UNITED STATES PATENT AND TRADEMARK OFFICE

APPLICATION NO.	FILING DATE	FIRST NAMED INVENTOR	ATTORNEY DOCKET NO.	CONFIRMATION NO.
09/390,435	09/07/1999	JOHN G. SPAKOUSKY	6479	6931

Office Action Summary

Art Unit: 3637

Appendix A

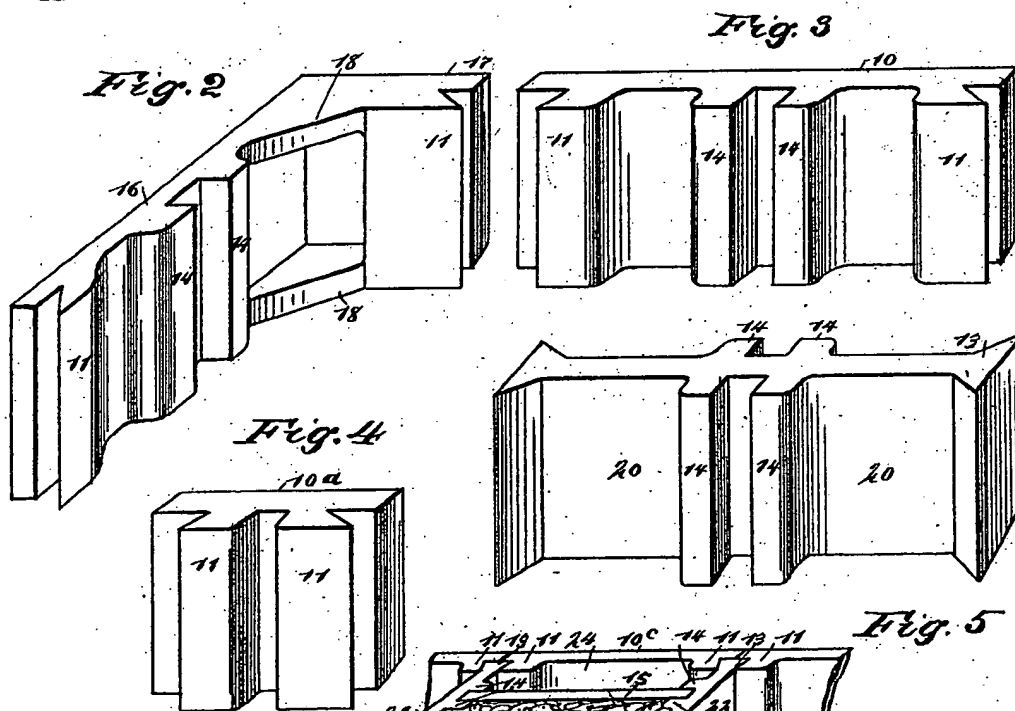
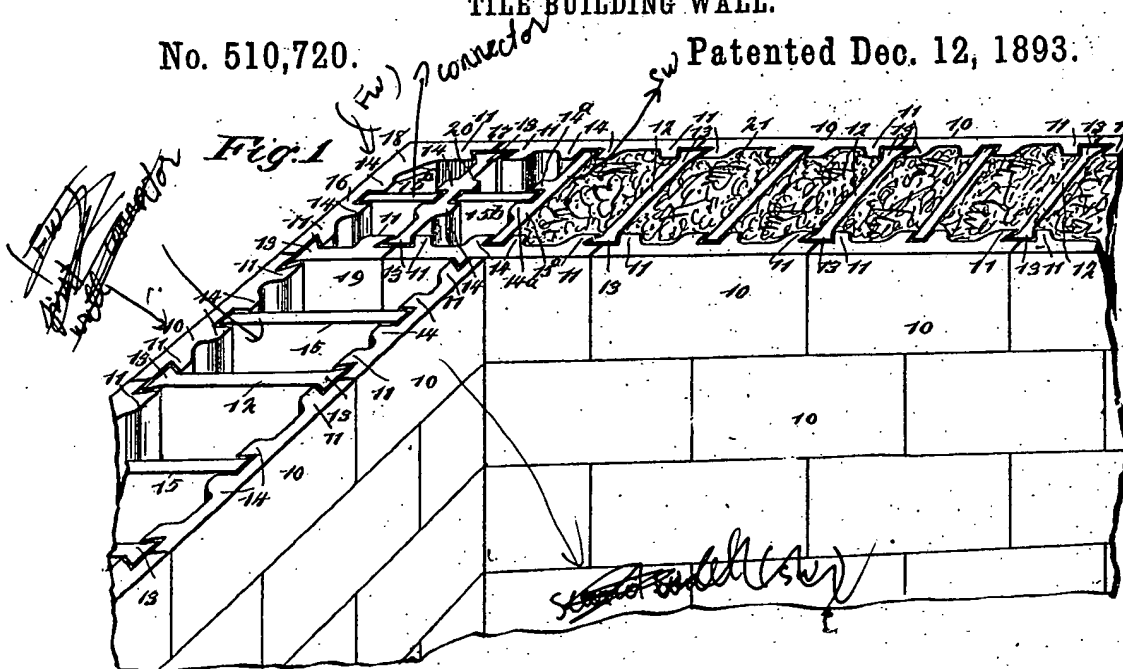
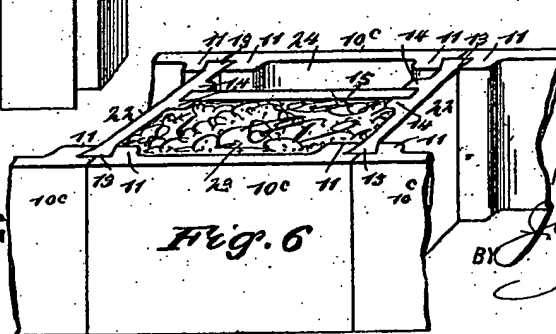
Stewart Jr. (appendix A) shows a discrete pre-assembled composite block unit having a first wall (FW), a second wall (SW), at least one of the which is load bearing for vertical loads and made from a first, masonry-type material, each of said wall having at least one mortar receiving surface (11) for forming a mortar joint with the adjacent block units, a connective

structure (15b) connected between the first and second walls, the connective structure having at least two connectors (13), each of the connectors being connected to one of the first and second walls, the walls being securely positioned with respect to one another as opposite faces of a discrete, substantially rectangular block, each face having a face area, the connective structure (15b) being free of direct structural connection to any wall of each adjacent block unit when the block unit is in a wall structure, the connective structure comprising arms (each half of the connectors) supporting the at least two connectors and said arms providing a thermal conduction path of limited cross-sectional area relative to either wall face area, a partition/form/center arm (20) forming a first and second cavity with the first and second wall.

Stewart Jr. does not show the connector being formed of a non-masonry material.

Stewart Jr. (figure 6) shows the partition forming a first cavity (23) being larger than the second cavity (24).
